Access Compliance Report

Public Rights-of-Way

(Curb Ramps)

Intersection ID: 20639	Main Street: CROWN_VIEW_DR	Cross Street: TOWER_POINT_DR	Location: NE
ADA ID: B5E3E3A8508A	Ramp Type: PerpDiag	Initial Pass/Fail: Fail	Overall Compliance: No
Severity Score: 50			
Codes/Mitigation Info/Possible Solution		Field Measurements/Component Compliance

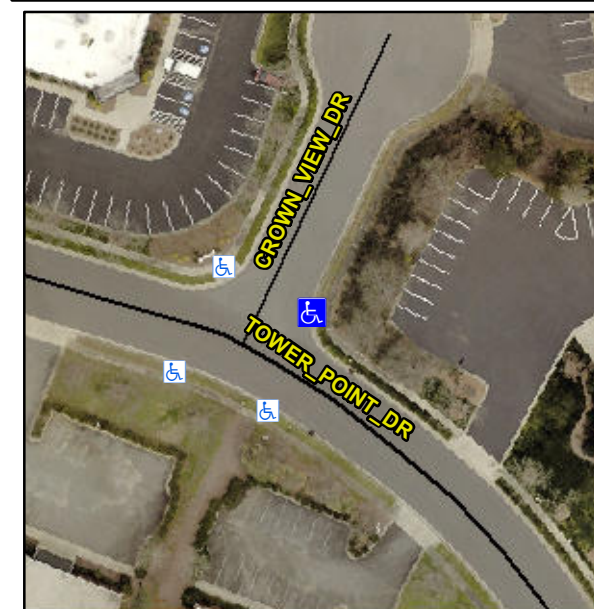
R304.2.2, R304.5.3

Compliance	Description	Data	Compliance	Description	Data
N/A	Ramp Length (in)	57.0	No	Ramp Slope (%)	14.9
Yes	Ramp Width (in)	48.0	No	Ramp XSlope (%)	10.8
N/A	Flare Type LT	N/A	N/A	Flare Type RT	N/A
N/A	Flare Slope LT (%)	N/A	N/A	Flare Slope RT (%)	N/A
N/A	Flare Traversable LT?	N/A	N/A	Flare Traversable RT?	N/A
N/A	Landing Length (in)	N/A	N/A	DWS Provided?	N/A
N/A	Landing Width (in)	N/A	N/A	DWS Contrast?	N/A
N/A	Landing Slope (%)	N/A	N/A	DWS Length (in)	N/A
N/A	Landing X Slope (%)	N/A	N/A	DWS Full Width?	N/A
N/A	Landing Curb? (Y/N)	N/A	N/A	DWS Offset (in)	N/A
N/A	Shared Landing?	N/A			
N/A	Gutter Ponding?	N/A	N/A	Gutter Slope (%)	N/A
N/A	Gutter Lip Ht (in)	N/A	N/A	Gutter X Slope (%)	N/A
N/A	Painted X Walk1?	No	N/A	Painted X Walk2?	No
	X Walk 1 Direction	To NW		X Walk 2 Direction	To SW
N/A	X Walk 1 Width (in)	N/A	N/A	X Walk 2 Width (in)	N/A
	X Walk 1 Slope (%)	3.2		X Walk 2 Slope (%)	10.9
	X Walk 1 X Slope (%)	6.3		X Walk 2 X Slope (%)	5.8

Remove & Replace Curb Ramp With Two New Directional Ramps or Equivalent.
